City of Richmond

Re: 5121Q – Richmond Ice centre HVAC Upgrade 2014- Addendum #2

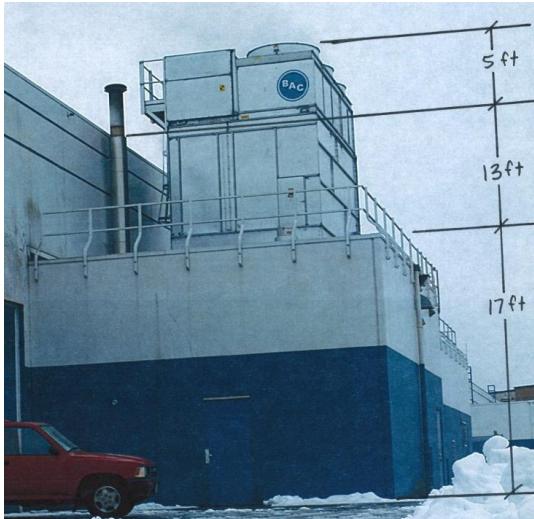
- 4.3 Paragraph 11: Replace the entire paragraph with the following, “Unit shall be 120VAC, single phase, less than 8 Amps (including powered pump) for connections to a 15A breaker. The control circuit shall be 24VAC.”
